1. Viewpack

4 HOWARD CT- HARDSCAPE.PDF
13 WARREN ST- REV 01-0557 ROTATE SHED PERGOLA.PDF
13 WARREN ST- REV 01-0558-GATE - FENCE.PDF
12 LINCOLN AVE - CABANA REVISIONS.PDF
12 LINCOLN AVE - GARAGE REVISIONS.PDF
25 UNION - HANDICAP RAMP.PDF
25 FEDERAL STREET - HVAC MINISPLIT.PDF
30 CLIFF RD- HOUSE LIFT AND FOUNDATION.PDF

Application to the HISTORIC DISTRICT COMMISSION, Nantucket, Massachusetts, for a

CERTIFICATE OF APPROPRIATENESS

1 Proposed Floor Plan
1/4" = 1'-0"

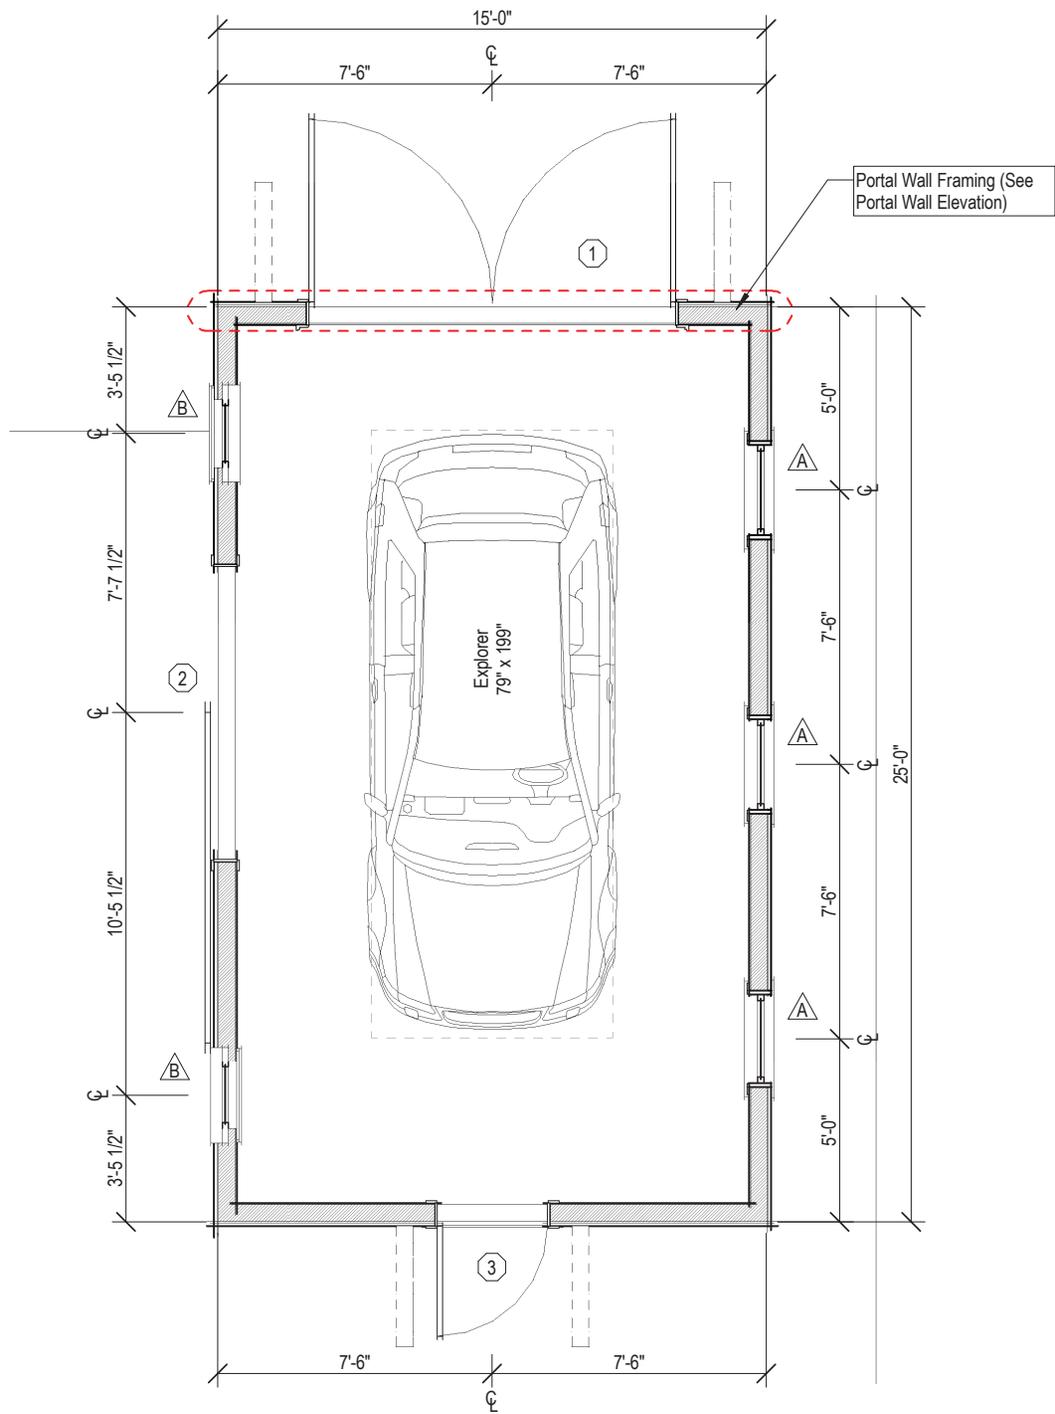
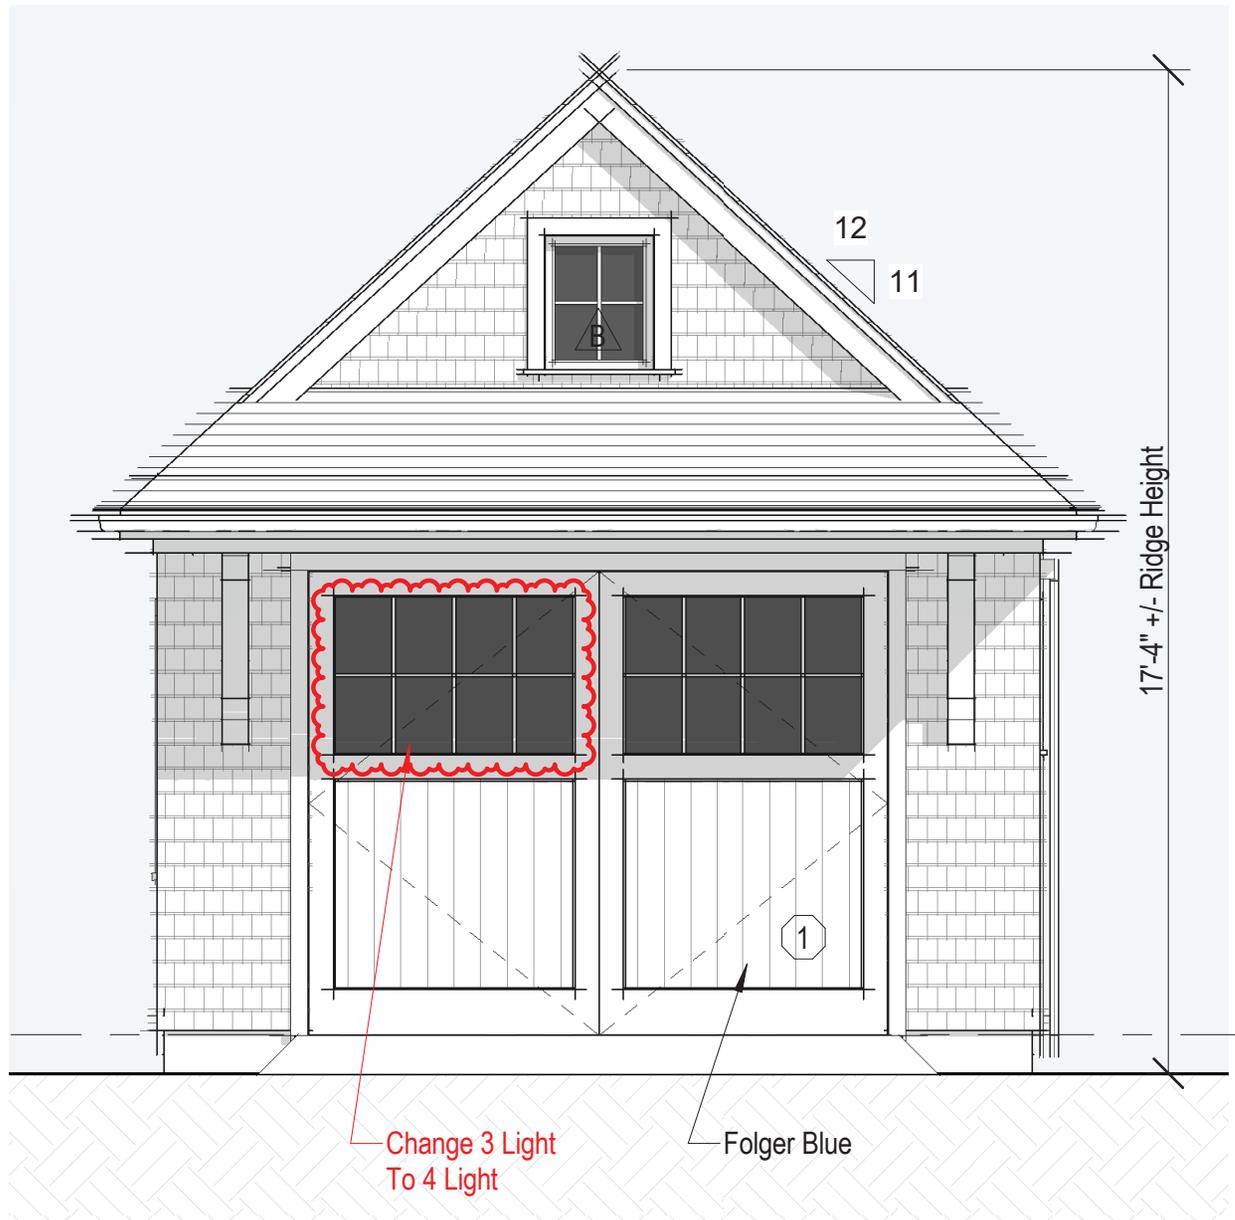
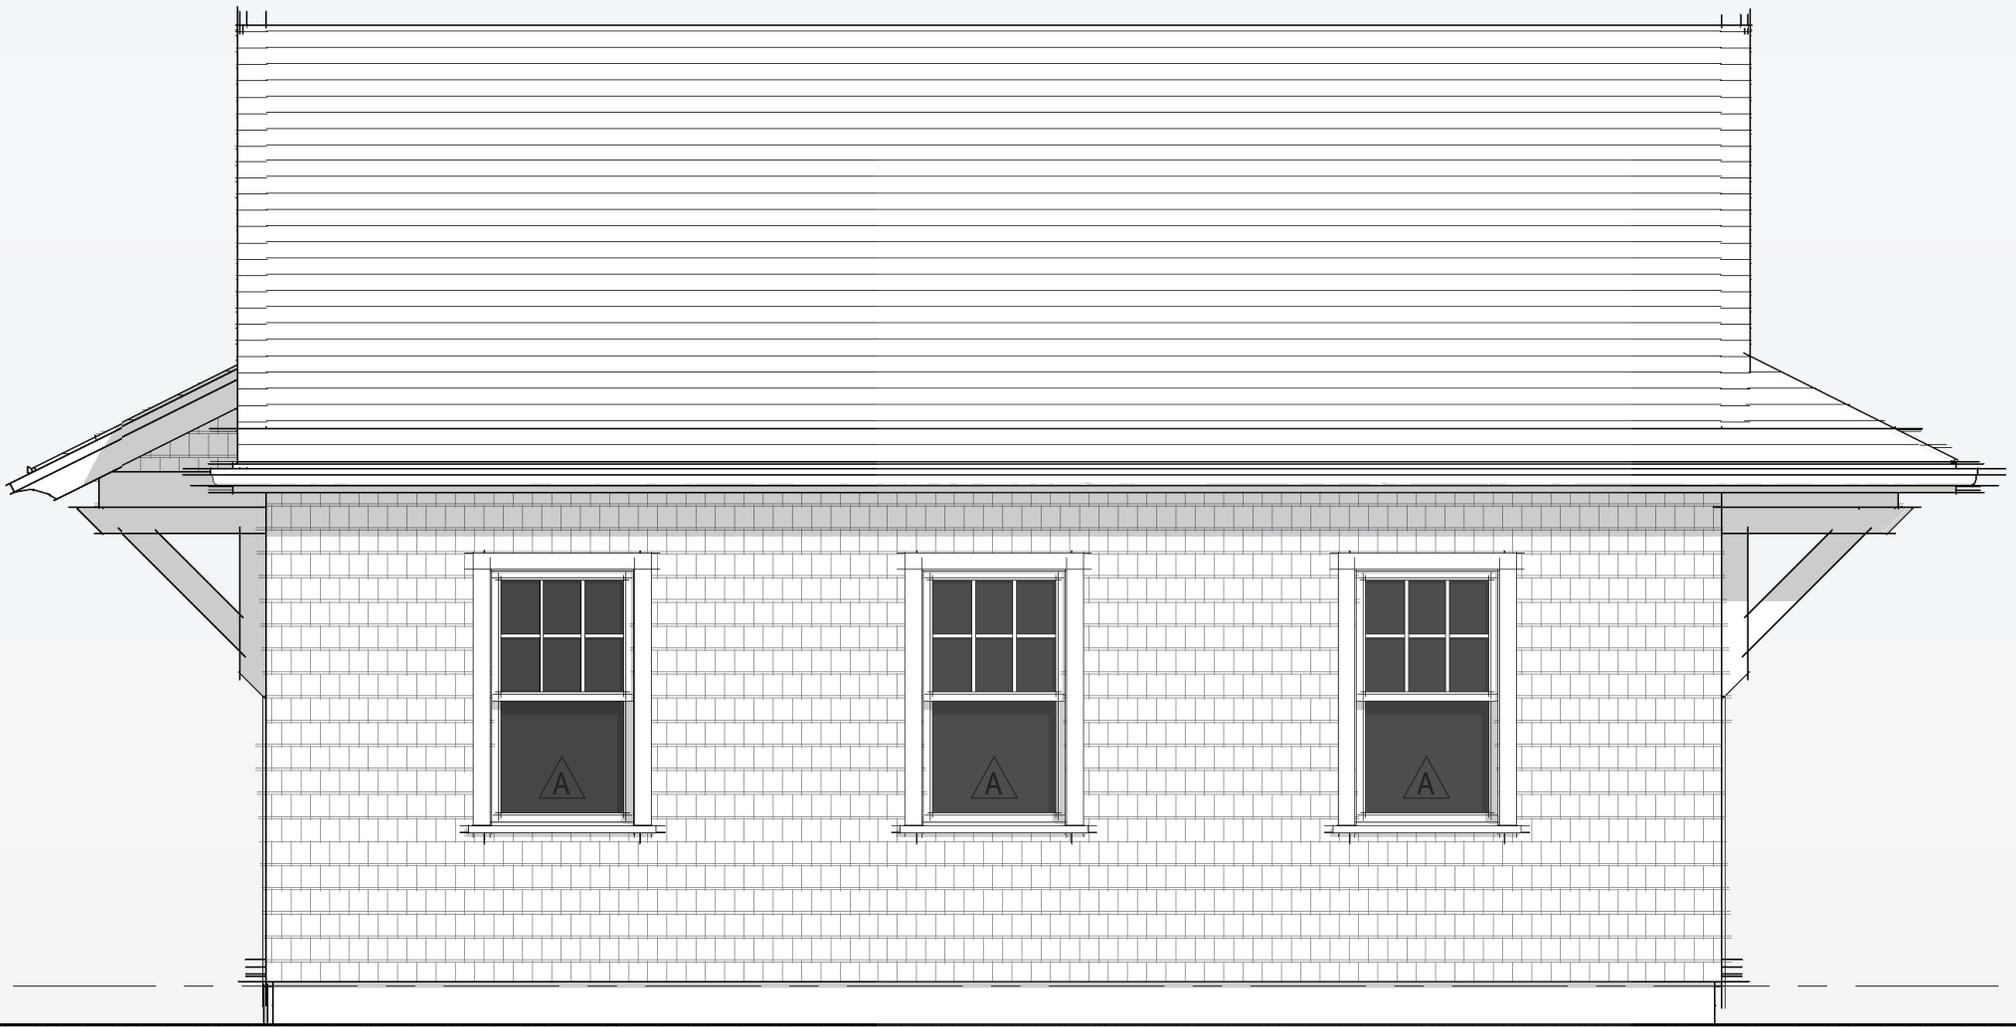
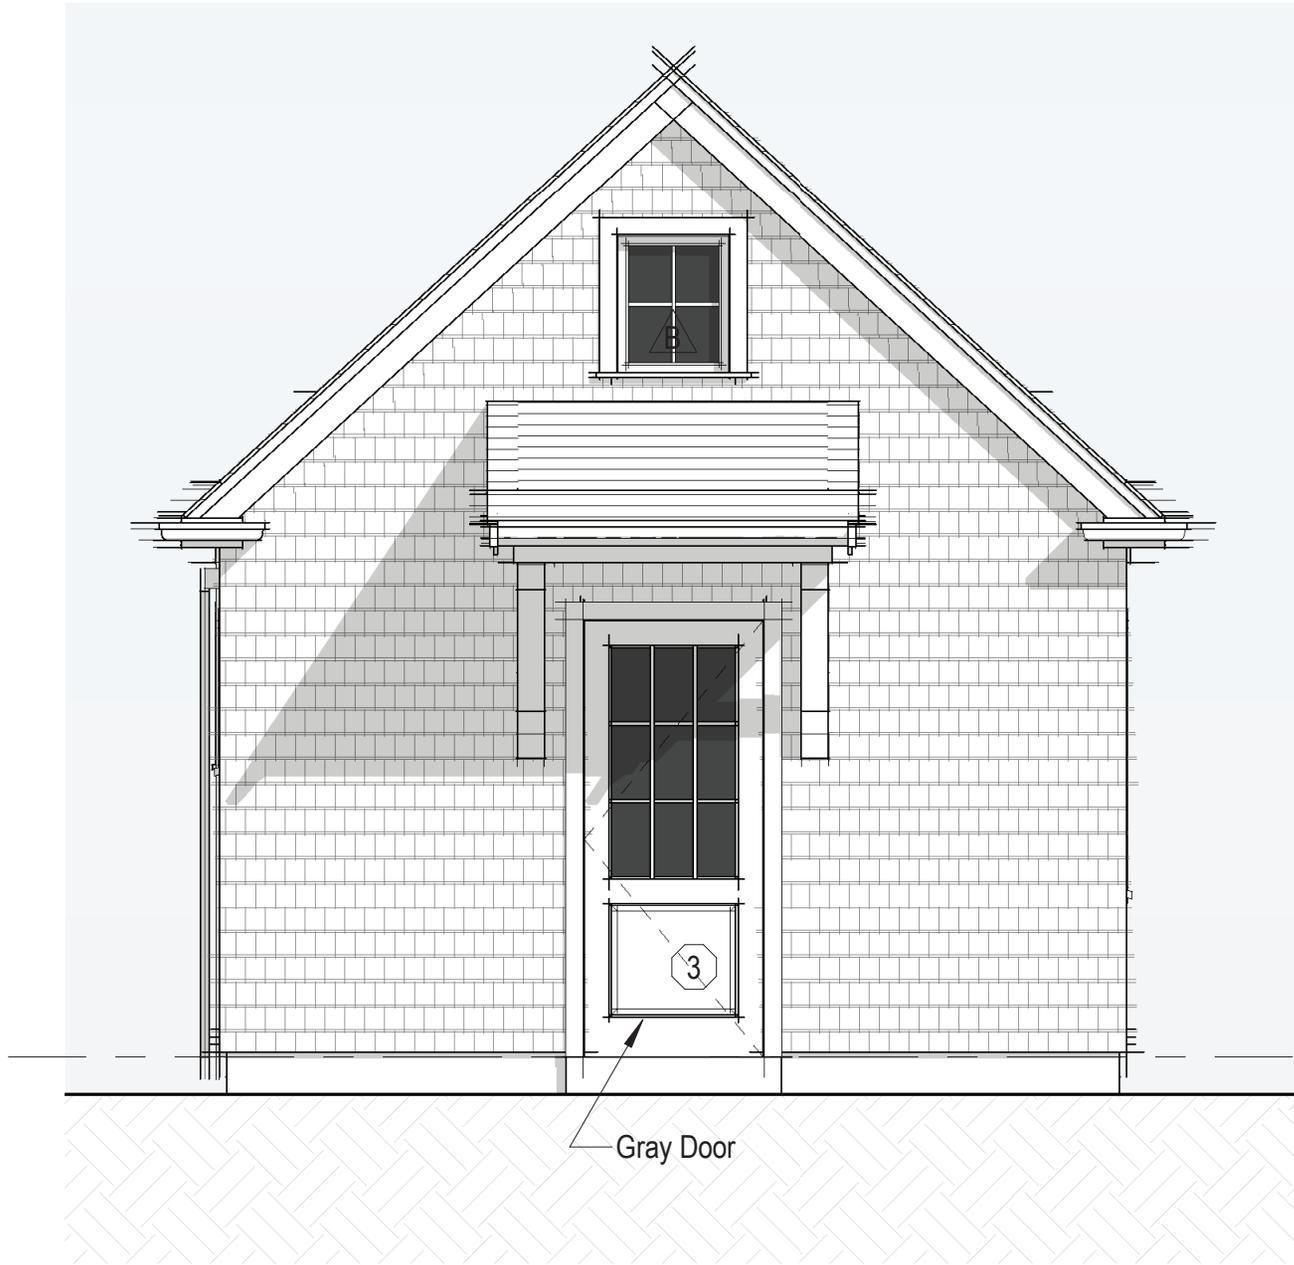
Historic Name: N/A **REVISIONS*** 1. East Elevation
 Original Date: _____ (describe) 2. South Elevation
 Original Builder: _____ 3. West Elevation
 Is there an HDC survey form for this building attached? Yes N/A 4. North Elevation Change 6 light door to 8 light
